MEMO

To: **Todd & Walker Law attn. Rosie Hill**
 From: Paddy Baxter Baxter Design
 Re: **RC 230179** **Scope / Key Changes / Effects Summary**

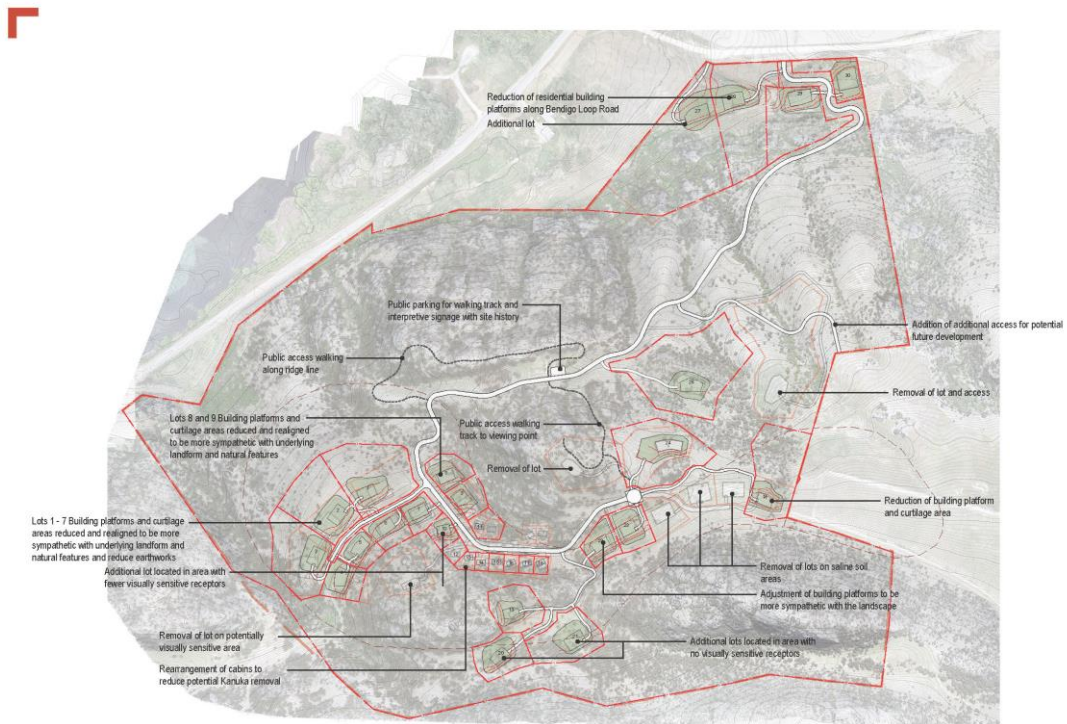
1. We have been asked to supply a brief overview of the key changes undertaken and the scope of those changes, with particular regard to those changes adjacent to Bendigo Loop Road as lodged by the applicant on 29th July 2024 and the subsequent changes following a boundary line adjustment decision.
2. The changes to the application were shown on the sheet below.

The above image was produced on September 2nd to summarise the changes to the scheme plan submitted on July 29th. The boundary adjustment is not shown on this diagram as it is no longer part of this application.

3. From a landscape effects perspective, the relocation of the cabins (lots 11-18), the removal of 6 residential lots in the upper area, the relocation of 3 lots (10,20 and 21) have resulted in a reduction in wider potential adverse effects arising from development in that landscape.

4. Subsequent to submitting documentation on the 29th of July 2024, the proposed boundary adjustment was removed from the scheme plan, with lots 27 – 30 being realigned. These changes have resulted in a no changes in the wider potential adverse effects arising from development in that landscape.

5. In regards to the scope of change arising from the potential development of the 4 lots adjacent to Bendigo Loop Road the following is noted:
 - The site coverage on the 3 original proposed lots adjacent to Bendigo Loop Road have all been substantially reduced from 475m² to 350m² on lot 28, from 1160m² to 350m² on lot 29 and from 440m² to 350m² on Lot 30.

- The additional lot 27 has the same site coverage requirements being 350m².
6. More rigour has been applied to the proposed development by way of design control on these proposed lots, reducing the size of permitted structures on the lots from that originally applied for, with a maximum of 5 metres height on all of these 4 lots and a limited palette of colours and claddings to ensure a contiguous amenity appropriate for that landscape setting.
